BCA Assessment Report

SEED Lot 1
1669-1732 & 1669A Elizabeth Drive, Badgerys Creek
NSW

Mirvac

19 February 2026
Reference: 250384

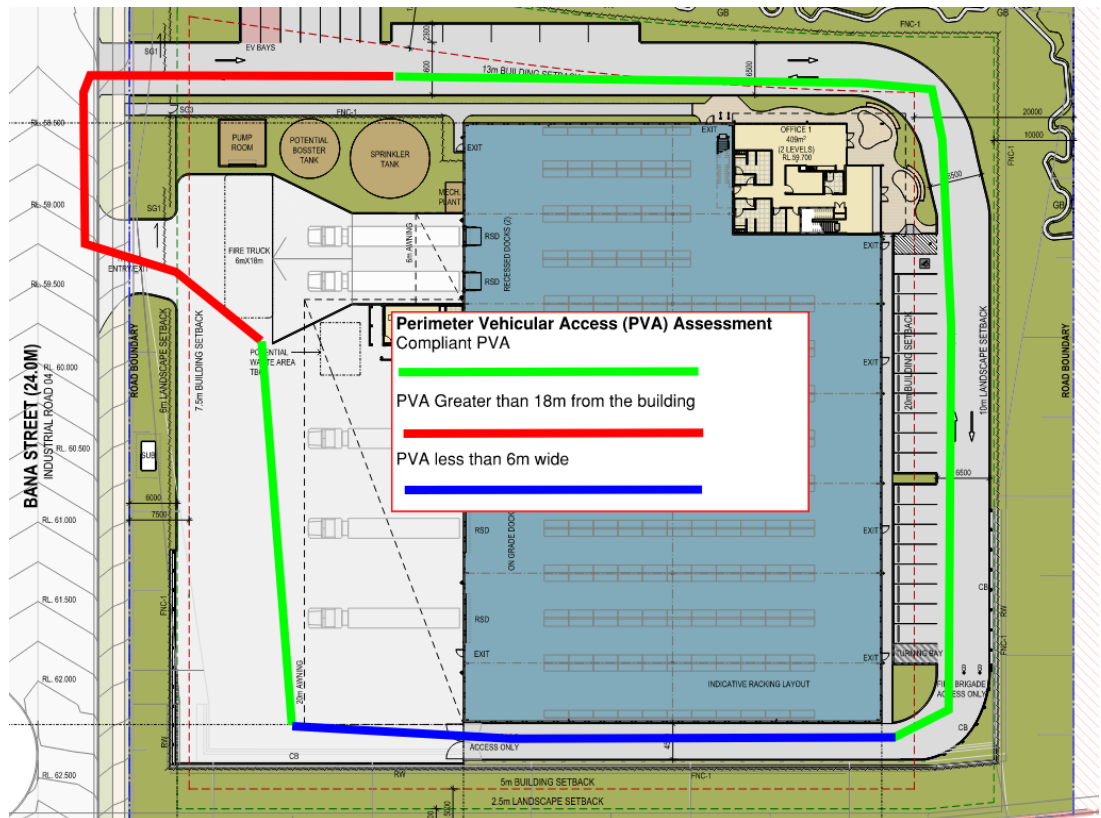
C3D5	Requirements for Open Spaces and Vehicular Access: Open space and vehicular access required by C3D4 must comply with the requirements of sub-clauses (a) & (b) of this Part whereby they must be 6m wide within 18m of the external walls of the building and of a suitable bearing capacity and unobstructed height to permit the operation and passage of FRNSW vehicles. Comment: The proposed building does not comply with the provisions of C3D5 and thus the following non-compliance issues are required to be addressed as a Performance Solution by the Fire Engineer to demonstrate compliance with Performance Requirement C1P9: + To allow PVA to be more than 18m on the northern side of the building.

- + To allow the PVA pathway to be less than 6m wide on the western side of the building.

Note 1: Any proposed gates are to achieve no less than 6m unobstructed width or the reduced width will need to be included in the above Performance Solution.

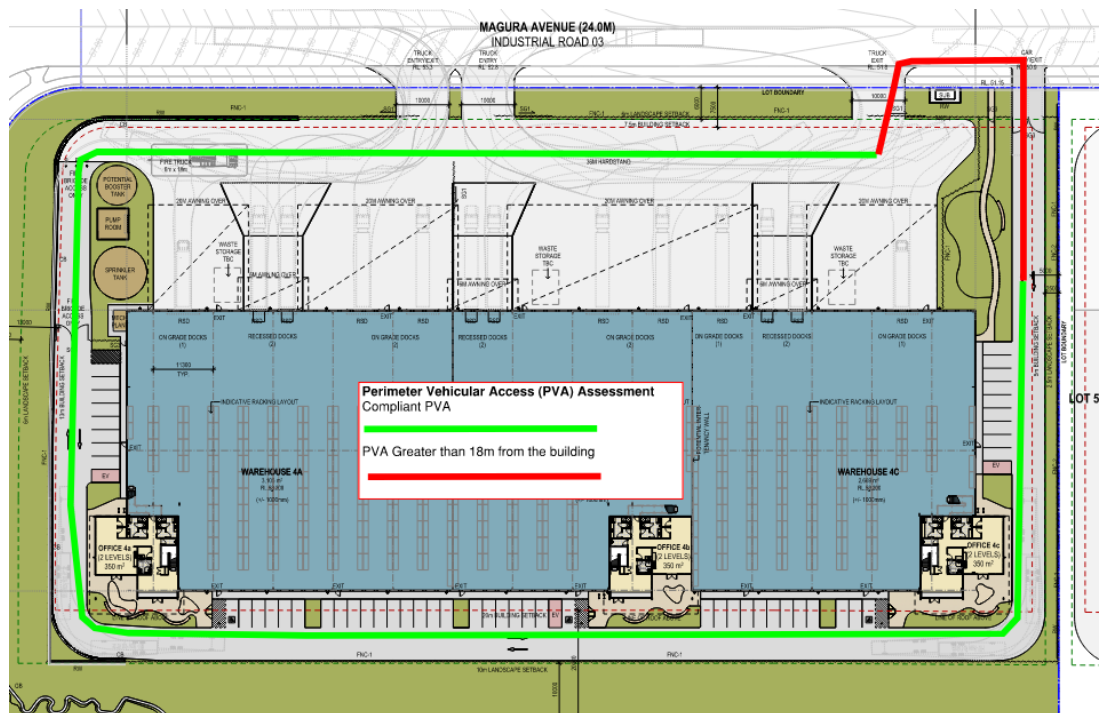
C3D5	Requirements for Open Spaces and Vehicular Access: Open space and vehicular access required by C3D4 must comply with the requirements of sub-clauses (a) & (b) of this Part whereby they must be 6m wide within 18m of the external walls of the building and of a suitable bearing capacity and unobstructed height to permit the operation and passage of FRNSW vehicles. Comment: The proposed building does not comply with the provisions of C3D5 and thus the following non-compliance issues are required to be addressed as a Performance Solution by the Fire Engineer to demonstrate compliance with Performance Requirement C1P9:

- + To allow perimeter vehicular access to be more than 18m on the northern side of the building.

Note 1: Any proposed gates are to achieve no less than 6m unobstructed width or the reduced width will need to be included in the above Performance Solution.

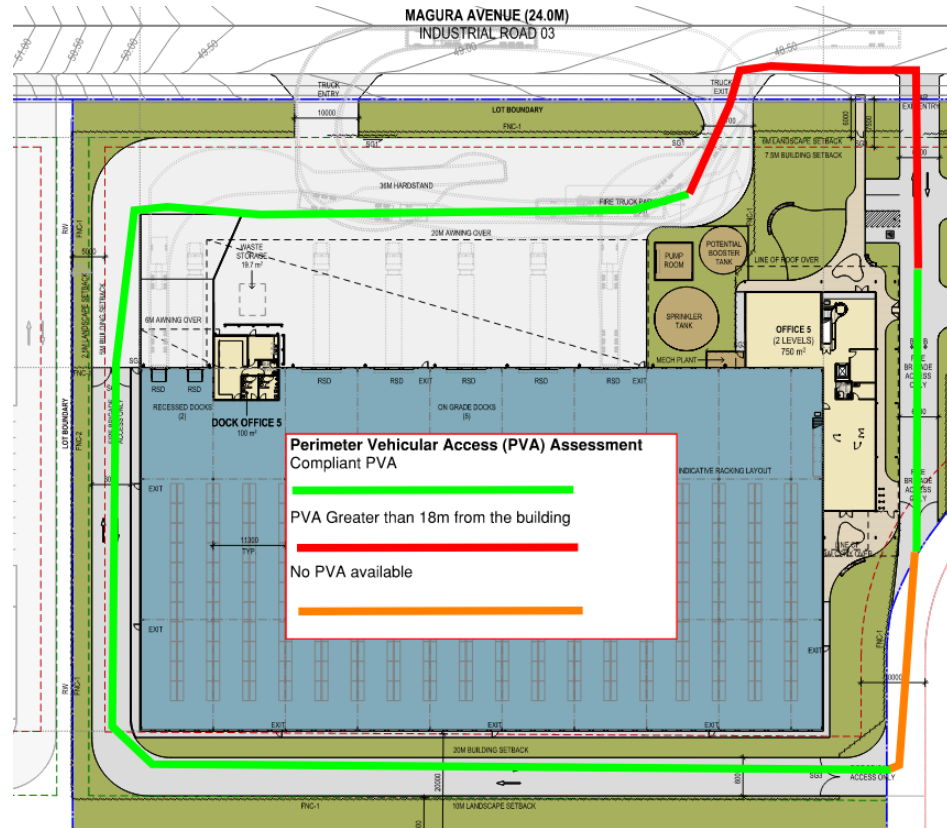
C3D5	Requirements for Open Spaces and Vehicular Access: Open space and vehicular access required by C3D4 must comply with the requirements of sub-clauses (a) & (b) of this Part whereby they must be 6m wide within 18m of the external walls of the building and of a suitable bearing capacity and unobstructed height to permit the operation and passage of FRNSW vehicles. Comment: The proposed building does not comply with the provisions of C3D5 and thus the following non-compliance issues are required to be addressed as a Performance Solution by the Fire Engineer to demonstrate compliance with Performance Requirement C1P9: + To allow perimeter vehicular access to be more than 18m on the northern side of the building.

- + The eastern and southern sides of the building require the PVA to pass through a pedestrian/cycle pathway. This would not be suitable for a PVA pathway. Further details to be provided to determine the suitability of this pathway.

Note 1: Any proposed gates are to achieve no less than 6m unobstructed width or the reduced width will need to be included in the above Performance Solution.

Figure 2 – Perimeter Vehicular Access Assessment

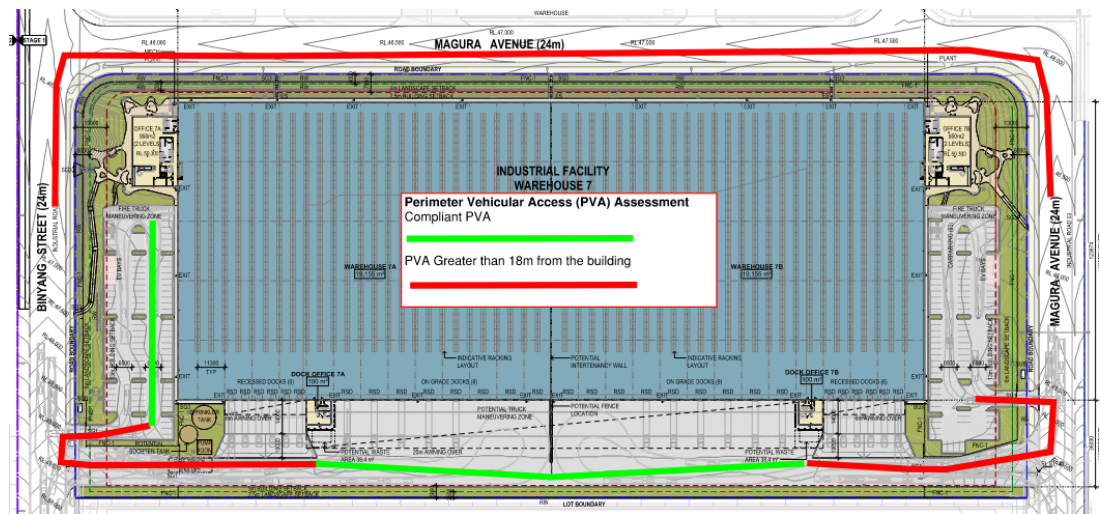
C3D5	Requirements for Open Spaces and Vehicular Access: Open space and vehicular access required by C3D4 must comply with the requirements of sub-clauses (a) & (b) of this Part whereby they must be 6m wide within 18m of the external walls of the building and of a suitable bearing capacity and unobstructed height to permit the operation and passage of FRNSW vehicles. Comment: The proposed building does not comply with the provisions of C3D5 and thus the following non-compliance issues are required to be addressed as a Performance Solution by the Fire Engineer to demonstrate compliance with Performance Requirement C1P9:

- + To allow perimeter vehicular access to be more than 18m from all four sides of the building.

Note 1: Any proposed gates are to achieve no less than 6m unobstructed width or the reduced width will need to be included in the above Performance Solution.

Figure 2 – Perimeter Vehicular Access Assessment

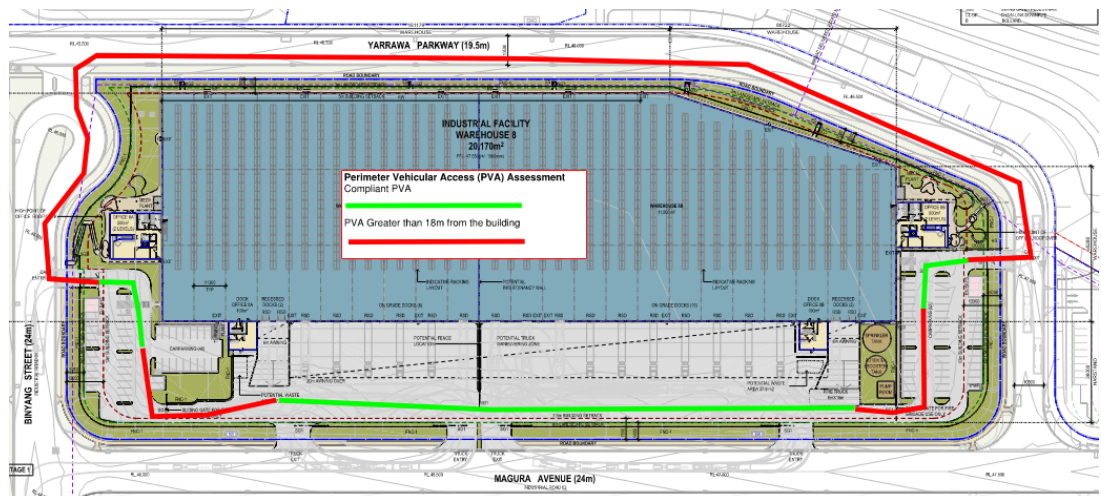
C3D5	Requirements for Open Spaces and Vehicular Access: Open space and vehicular access required by C3D4 must comply with the requirements of sub-clauses (a) & (b) of this Part whereby they must be 6m wide within 18m of the external walls of the building and of a suitable bearing capacity and unobstructed height to permit the operation and passage of FRNSW vehicles. Comment: The proposed building does not comply with the provisions of C3D5 and thus the following non-compliance issues are required to be addressed as a Performance Solution by the Fire Engineer to demonstrate compliance with Performance Requirement C1P9:

- + To allow perimeter vehicular access to be more than 18m from all four sides of the building.

Note 1: Any proposed gates are to achieve no less than 6m unobstructed width or the reduced width will need to be included in the above Performance Solution.
